CORSAIR MARINE INC.
150 Center St., Chula Vista, CA 92011

F-27 WING NETS

Date : 3/22/90 I.L.F.

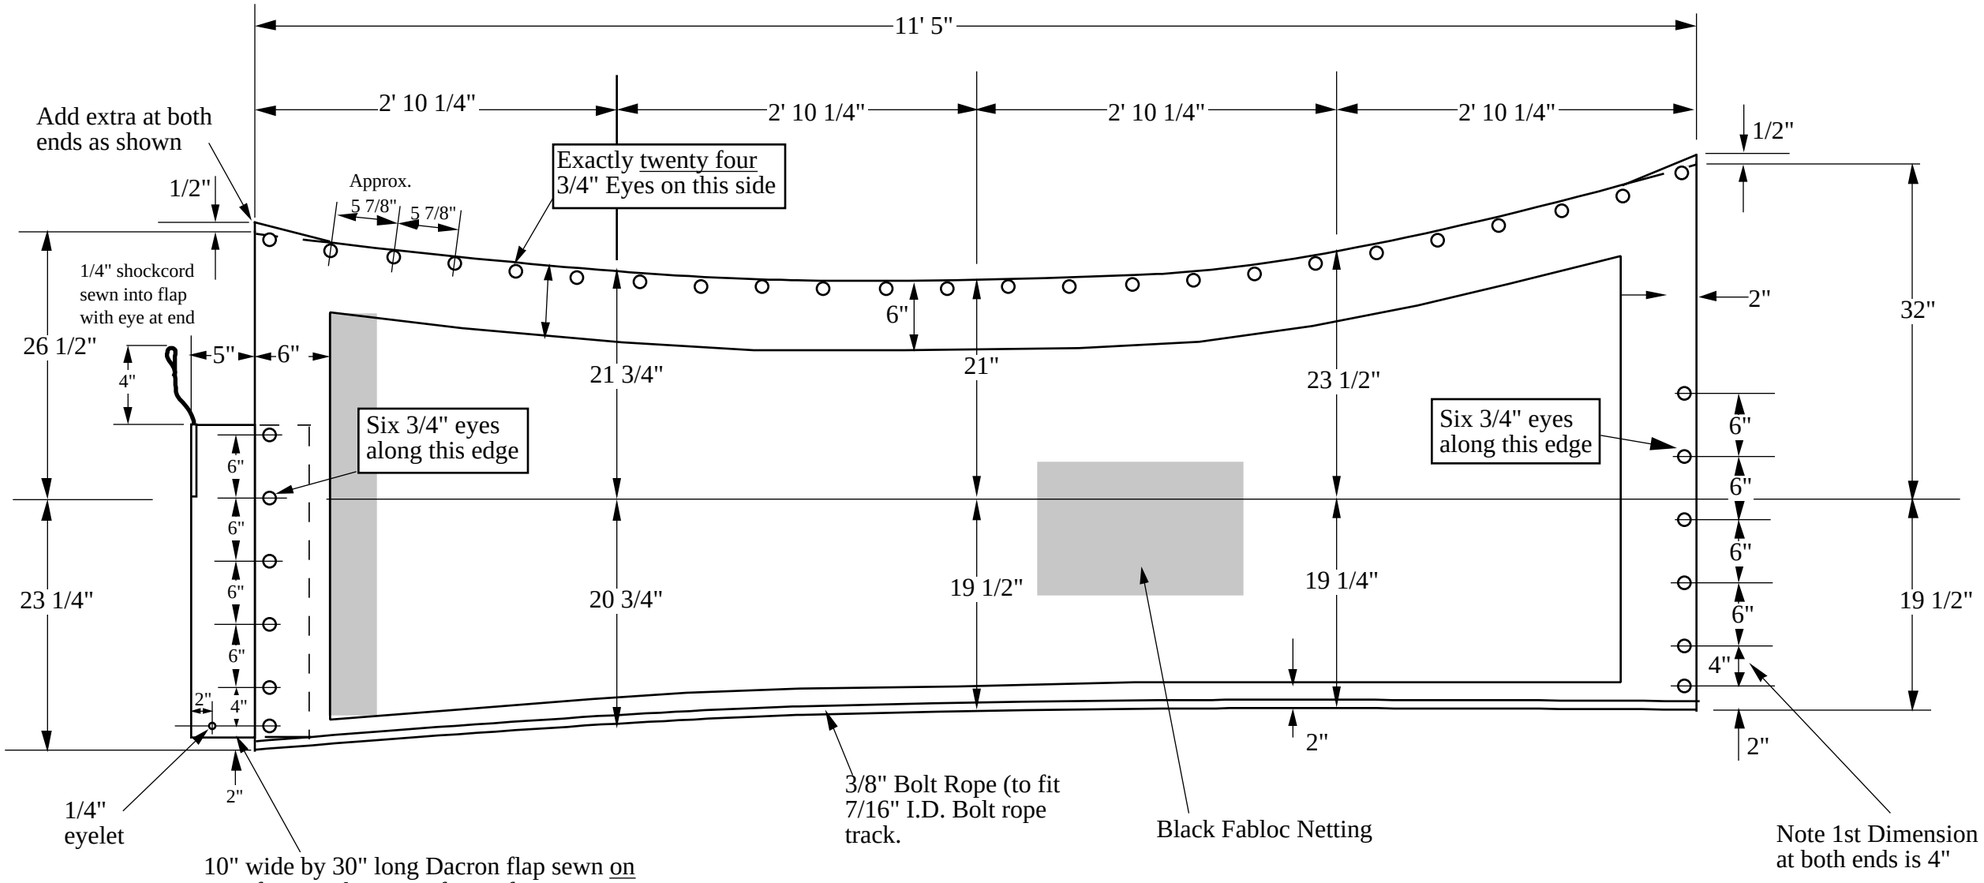
Changes 3/22/90
Aft flap reduced to 10" wide and now extends aft 5".
One eyelet on flap eliminated
Dacron Tape width on edges increased to 6" wide.as shown
